Service Bulletin

E245

PACCAR MX-13 EPA13 EMY 2013 to 2015A NOx Emissions Improvement and On Board Diagnostic (OBD) system readiness and other OBD system software related issues. This bulletin supersedes E241.

E245 Emissions Recall

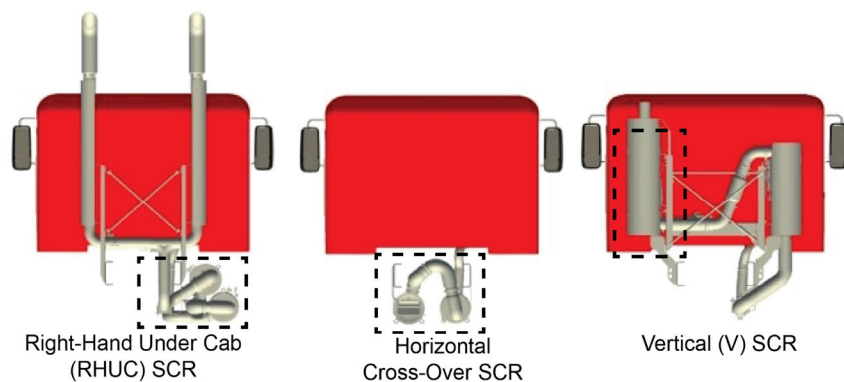
Chassis with RHUC SCR configurations, the NH3 Ammonia sensor will no longer be used by the engine software. The sensor is left in place to plug the hole.

Chassis with Vertical SCR configurations, the SCR is being replaced. The updated SCR will have a PM sensor hole that is not used in this configuration. The hole will be plugged. The NH3 sensor and ECU will be removed and the harness connector will be blocked off with a special connector.

Chassis with Horizontal Crossover SCR configurations receive no physical modifications to the aftertreatment system. After installing the engine software update, the NH3 Ammonia sensor will no longer be used by the engine software. The sensor is left in place to plug the hole.

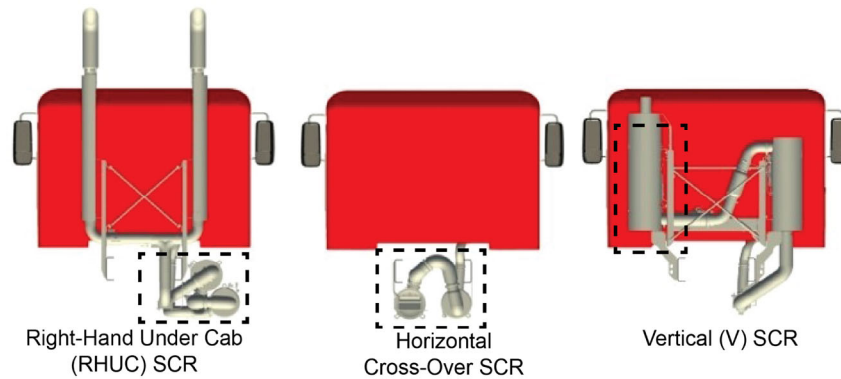
Chassis with RHUC SCR configurations, the NH3 Ammonia sensor will no longer be used by the engine software. The sensor is left in place to plug the hole.

Chassis with Vertical SCR configurations, the SCR is being replaced. The updated SCR will have a PM sensor hole that is not used in this configuration. The hole will be plugged. The NH3 sensor and ECU will be removed and the harness connector will be blocked off with a special connector.

Chassis with Horizontal Crossover SCR configurations receive no physical modifications to the aftertreatment system. After installing the engine software update, the NH3 Ammonia sensor will no longer be used by the engine software. The sensor is left in place to plug the hole.
